From: Steve Jones
Sent: Thursday, May 03, 2012 4:04 PM
To: Abigail Mayrena (AMayrena@regionalflood.org)
Cc: okwon@lasvegasnevada.gov; Todd Steadham (tsteadham@shg-inc.com)
Subject: RE: Kyle Canyon exhibits
Attachments: Exhibit J - Regional Facilities Map.pdf

From: Abigail Mayrena [<mailto:AMayrena@regionalflood.org>]
Sent: Monday, April 30, 2012 10:09 AM
To: Steve Jones
Cc: Oh Sang Kwon, P.E. (okwon@lasvegasnevada.gov)
Subject: Kyle Canyon exhibits

KYLE CANYON MASTER DRAINAGE STUDY (RFCDD SUPP)
CCRFCDD REGIONAL FACILITIES MAP

EXHIBIT J

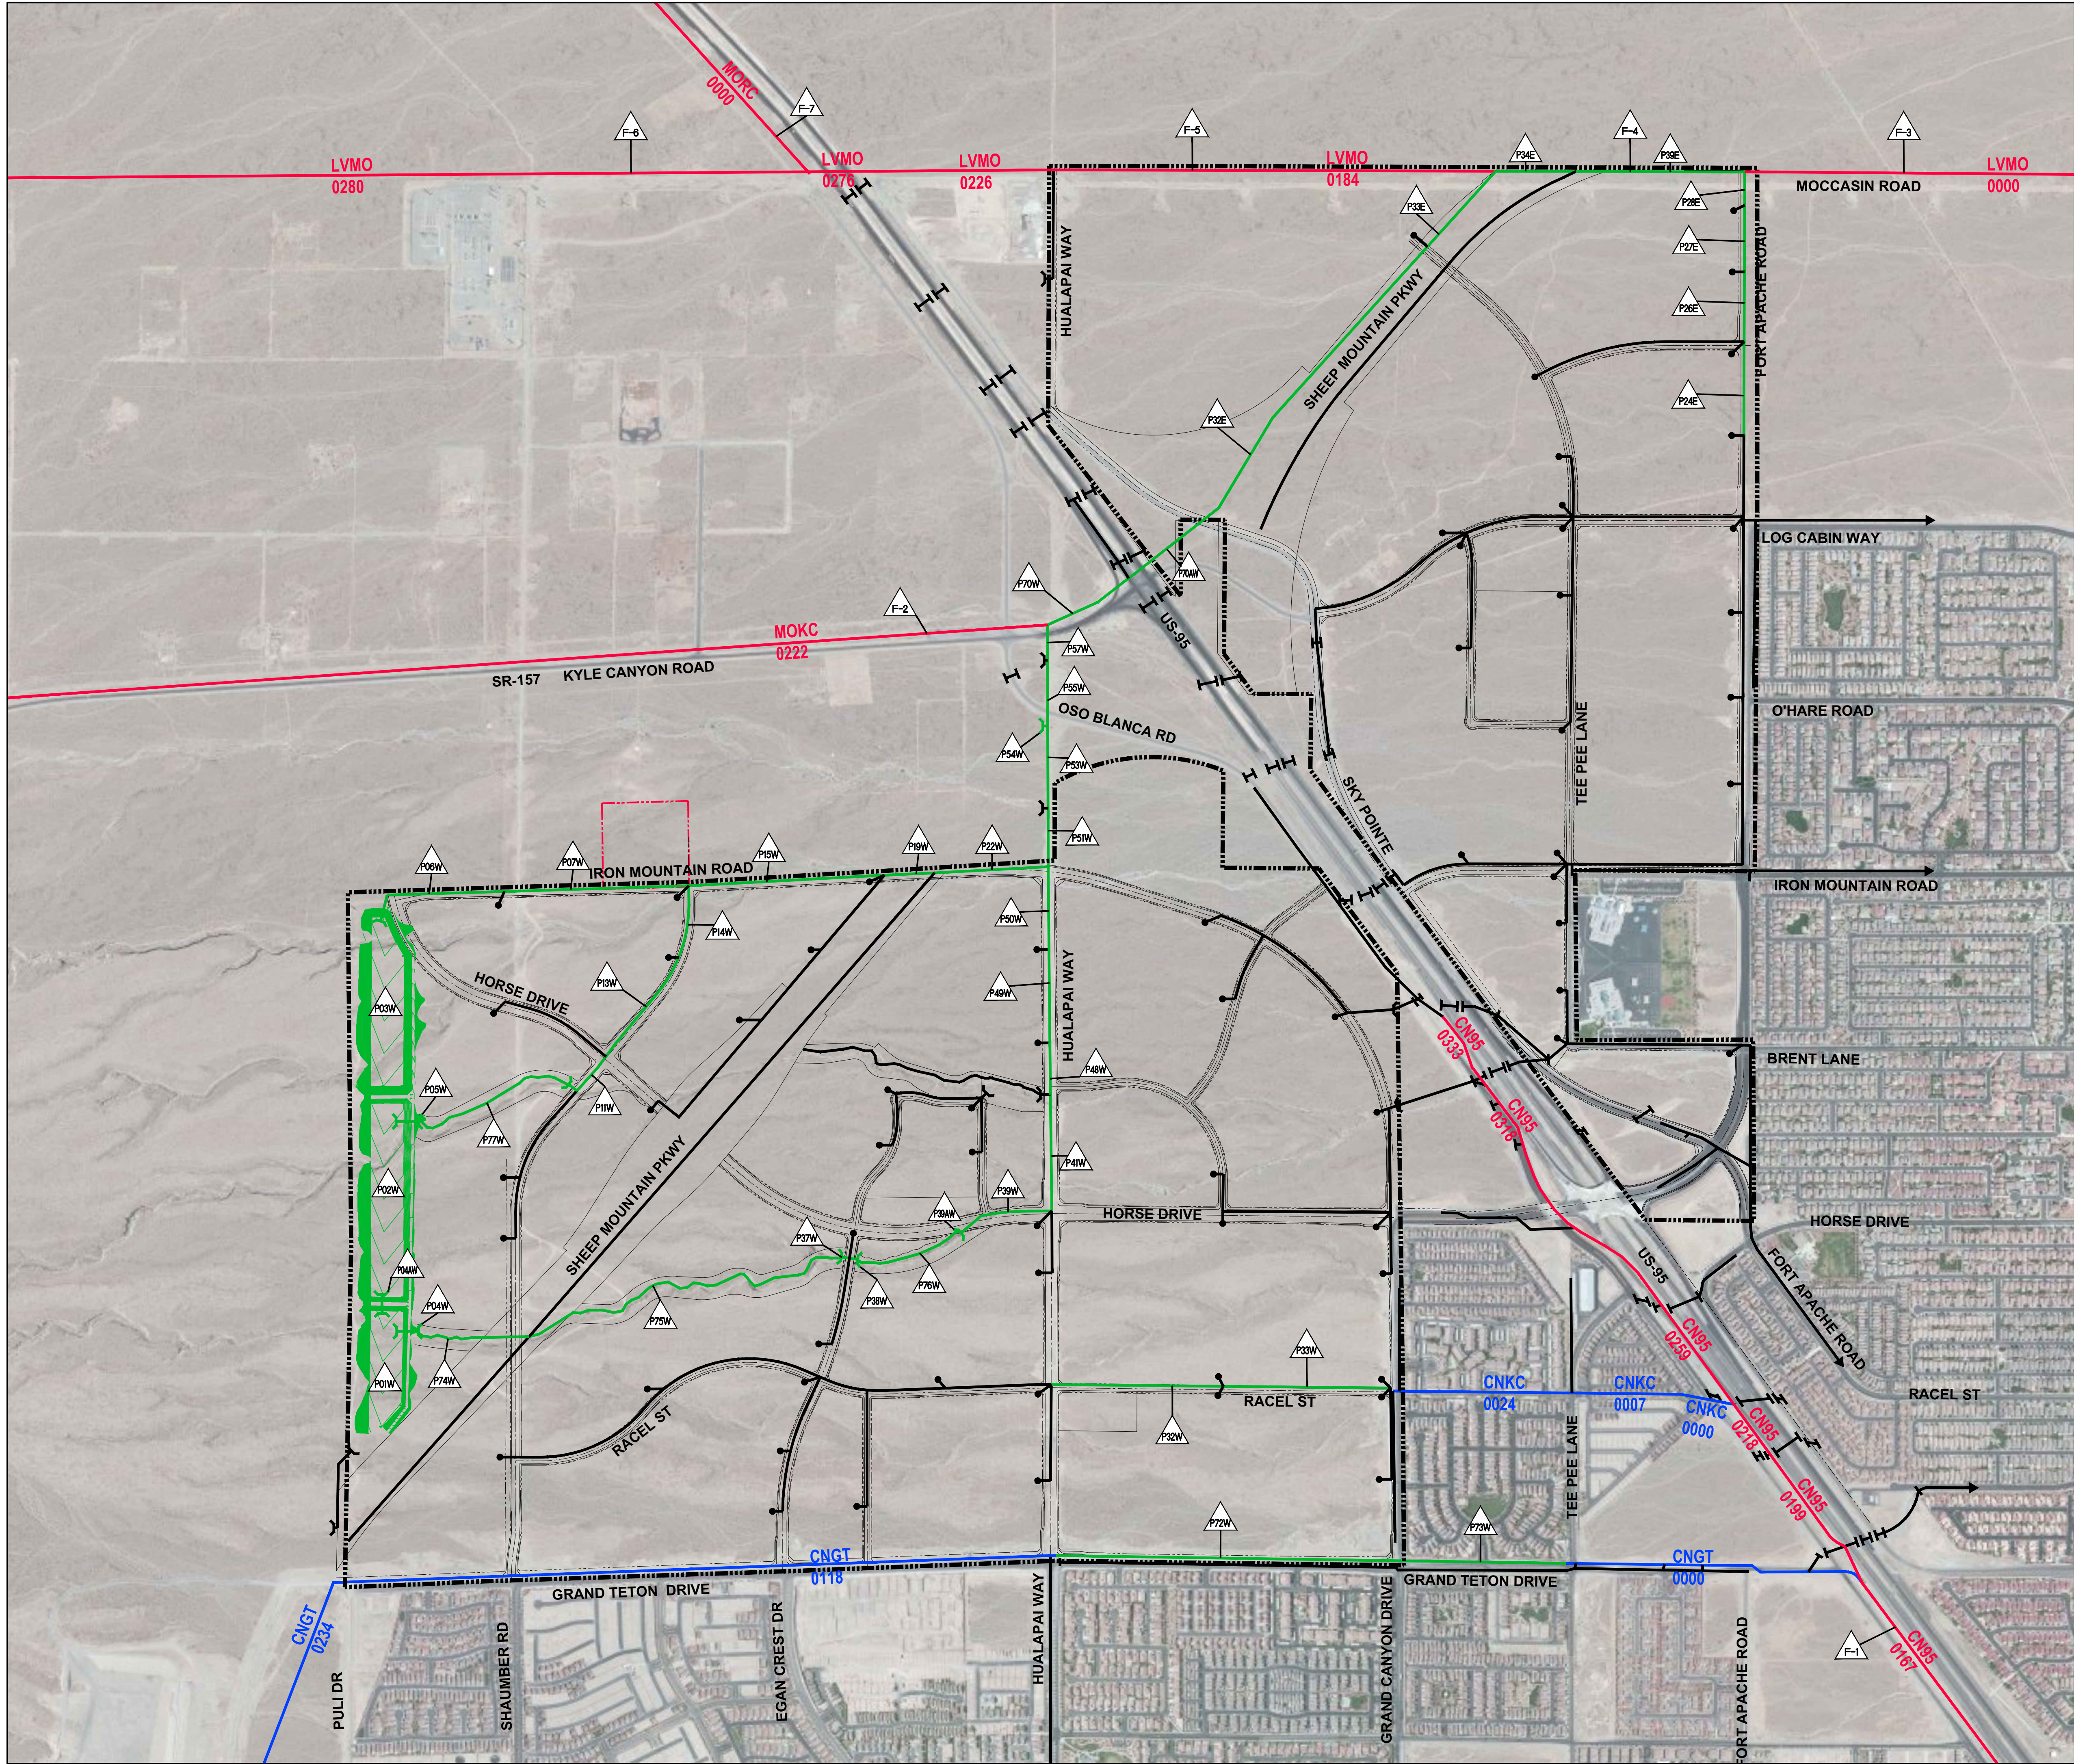
As discussed last week, can you revise U4 to be a Category B facility. I'll need the revised exhibits before I can process your concurrence letter. Can you also send the revised exhibits to CLV.

Facility U4 is intended to be constructed in the ultimate condition when Sheep Mountain Parkway is improved. Prior to Sheep Mountain Parkway improvements, the discharge from the regional detention basin Facility P01W (Facility P04W) is maintained in the existing southern arroyo and conveyed thru the Kyle Canyon site to the Hualapai Way alignment where it is conveyed north. Therefore, rather than revising the regional alignment after Sheep Mountain Parkway is complete and proposing a new developer financed (Category B) regional facility, Facility U4 has been changed to a future local facility and the regional alignment has been changed to match the proposed drainage condition presented in the CLV conditionally approved drainage study. Per the March 22, 2012 meeting with you and Andrew, this was determined an acceptable regional alignment to replace U4.

The attached Exhibit J and its summary table of West Regional Facilities has been updated accordingly. Note the only flow identified in the updated summary table that has not been updated is for Facility P22W; however, the flow reported and utilized for conceptual sizing of this facility included outflow from Detention Basin P01W which is considered conservative. Therefore, the reported flow and conceptual size for P22W is considered acceptable and the flow returns to as reported in the summary table at the next downstream facility (north of the intersection of Hualapai and Iron Mountain).
